Zoning Challenge and Appeal Form

BIS Job Number 122887224

Street Name Amsterdam Avenue

RE: Zoning Challenge 200 Amsterdam
Block 1158, Lot: 133, Job No:
122887224, Doc. 7

Plan of block 1158 with existing buildings, street addresses, tax and zoning lot lines

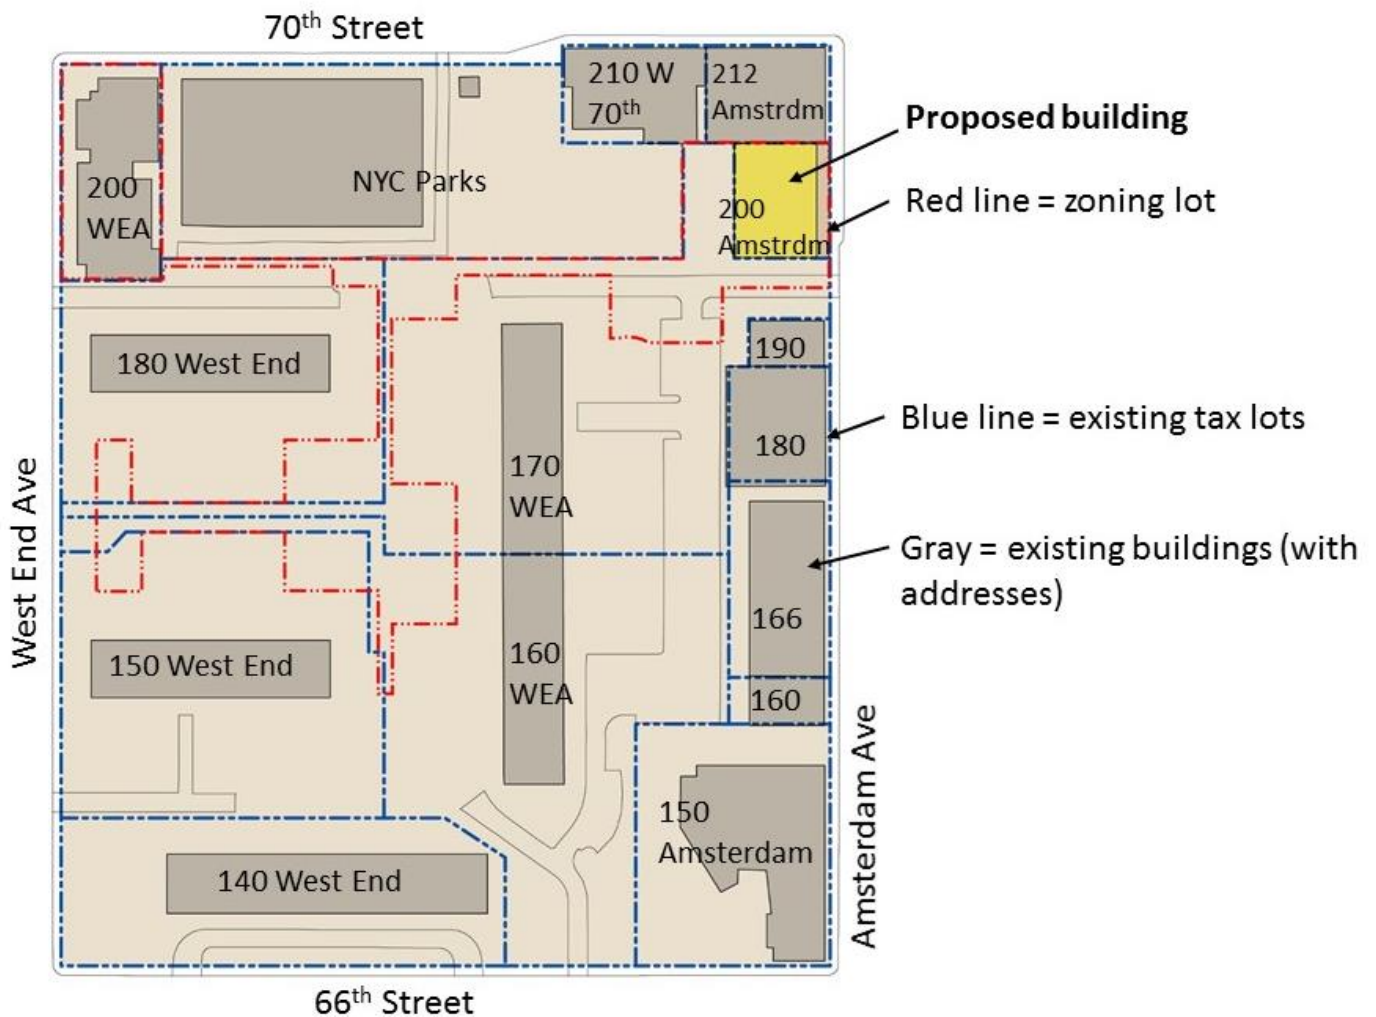
It obtains its exceptional height, in part, because ample floor-to-floor heights and large mechanical spaces; building mechanicals are enclosed in the top four floors of the building and are 67 feet tall. Most of its exceptional height, however, results from floor area generated by the enormous size of the irregular zoning lot on which it sits, which is 110,794 SF. The zoning lot is gerrymandered over much of superblock 1158; portions of it front West End Avenue, 70th Street, and Amsterdam Avenue. The zoning lot is partially a corner lot, partially a through lot, and mostly an interior lot.

The oddly shaped zoning lot is not new but was not well-known until recently. An extremely large zoning lot that included most of the superblock was created on the site in 1987. According to my office's research, the first gerrymandered lot was developed in 2007 and amended at least one time in 2016.

*Areas covered by the 1987 zoning lot classified by use of land (with 200 Amsterdam shown as constructed).
Gerrymandered zoning lot of 200 Amsterdam and 200 West End Avenue shown in red*

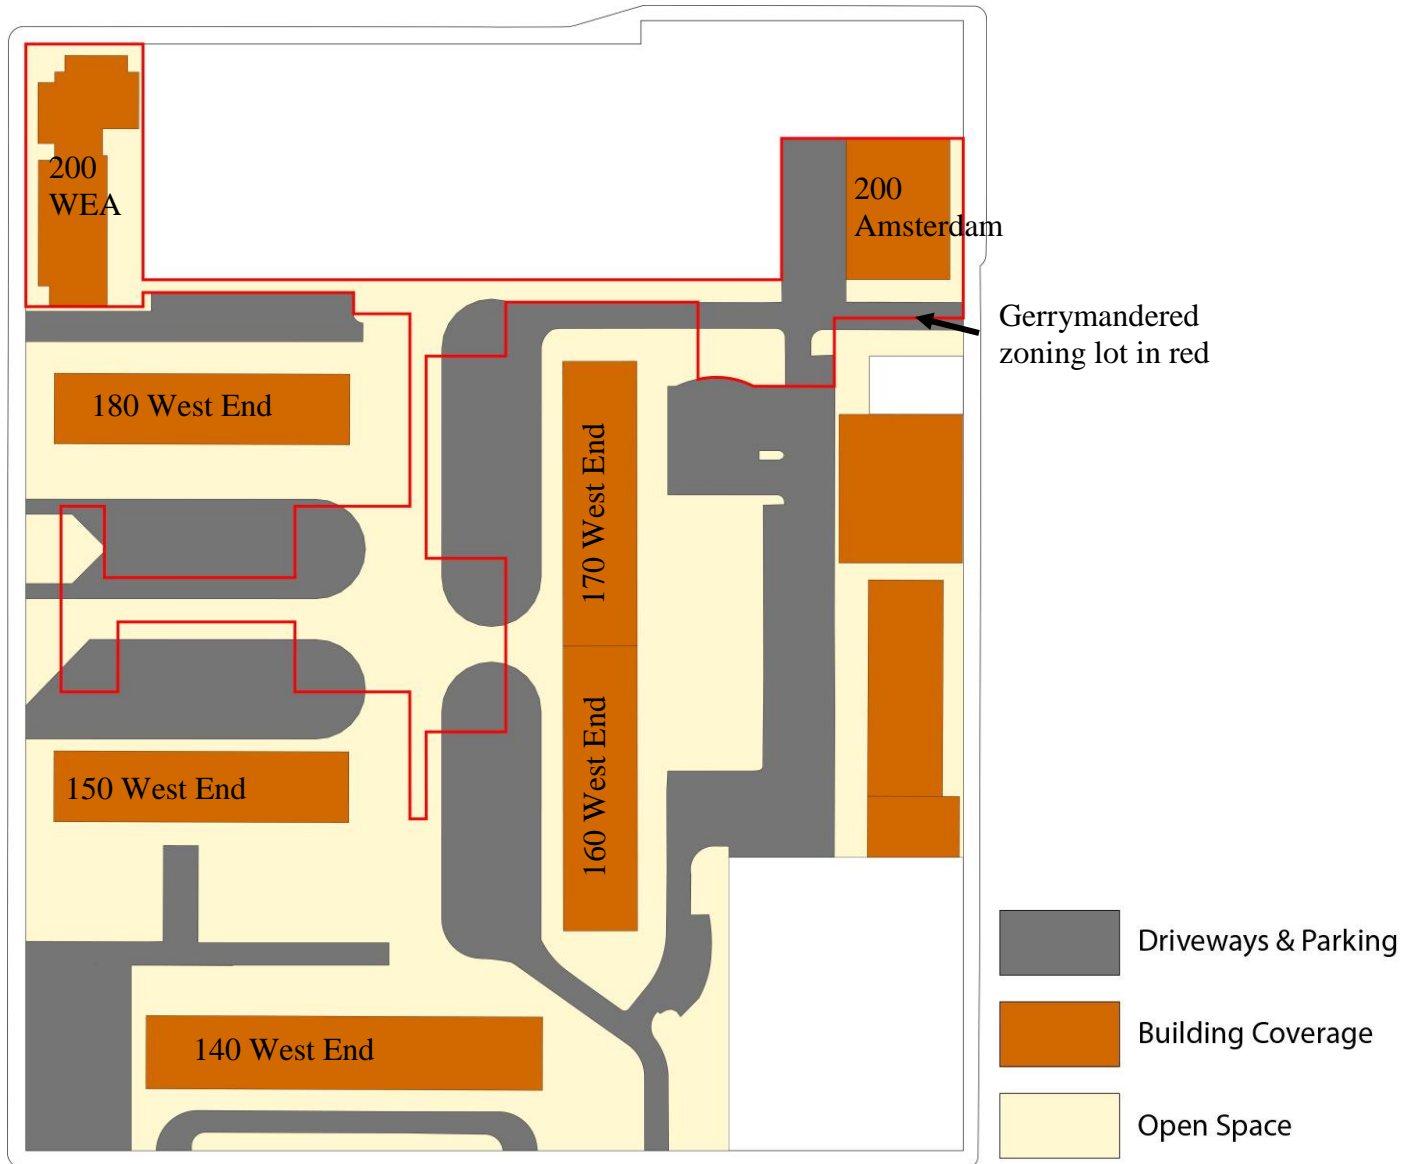
As stated in the Zoning Resolution, up to 50% of the required open space may be accessory parking, driveways, loading docks and bike parking. These uses are shown in gray above.

By my office's calculations, 33,983 SF of the open space on the gerrymandered lot is used for driveways and parking. According to 12-10, an Accessory use:

The parking and driveways are accessory to the uses on the Lincoln Towers zoning lot. They are not accessory to the uses on the gerrymandered lot since there is no parking provided for 200 Amsterdam or 200 West End Avenue. Uses accessory to another zoning lot are not permitted obstructions in Open Space, and thus, the 33,983 SF cannot be counted as open space in 200 Amsterdam's zoning calculations.

The building still complies according to FAR, but has nowhere near enough open space. At 8.7, the required Open Space ratio is 4.7 points too low, which is an *enormous* amount of open space considering the size of the development. I acknowledge that the measurements and the delineation of the parking areas was done from aerial photographs, and a survey of these areas could result in different measurements. But the amount of difference conceivable from a survey would not change this level of non-compliance: about 80% of the area now used as parking and driveways accessory to Lincoln Towers would have to be reclassified to complying open space for 200 Amsterdam to even approach compliance with the required open space ratio.

The sky exposure plane proposed for 200 Amsterdam. The top four floors break the sky exposure plane.

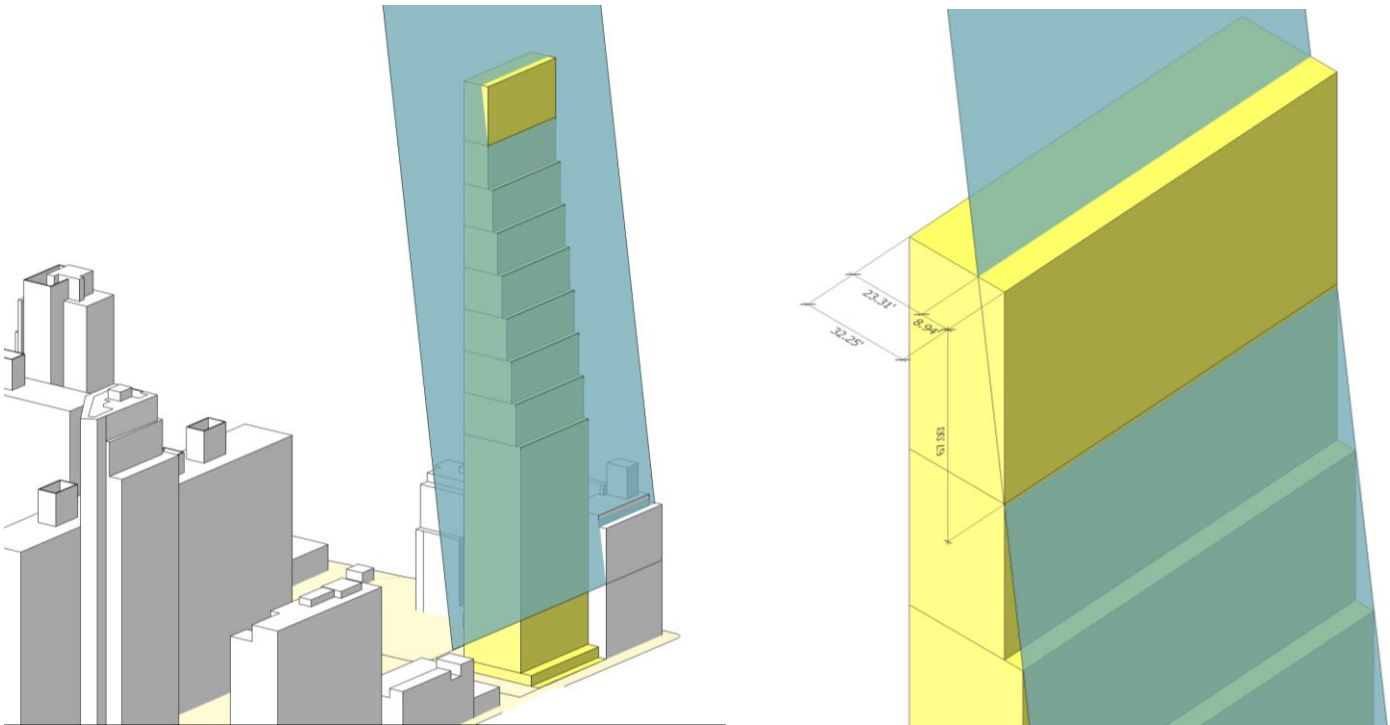
The ZD1 states, in effect, that the mechanical equipment located in floors 51 through 55 are permitted obstructions under 23-62(g). The question as to if the in-building mechanical floors may penetrate the sky exposure plane as a permitted obstruction hangs on the definition of “enclosures.” Unfortunately, this is not a defined term in the Zoning Resolution, but the applicant claims, and the Department has agreed, that enclosures may mean exterior building walls. This interpretation is in error, however, as it is not consistent with the New York State Multiple Dwelling Law (MDL).

While it is not a defined term in the MDL, the expression “superstructure” is used here, and elsewhere in the MDL, to refer to a structure that is on top of a building. The obvious interpretation of the MDL is that building height is measured to the top of the roof, with fairly wide exceptions for rooftop mechanicals, parapet walls and the like. The less obvious--and I would say incorrect interpretation--is that the first 50 feet of mechanicals can be exempted from building height. Either way, at 67 feet, the top four mechanical floors break the prescribed sky exposure and should not be considered permitted obstructions to maintain consistency with the MDL, as required by law.
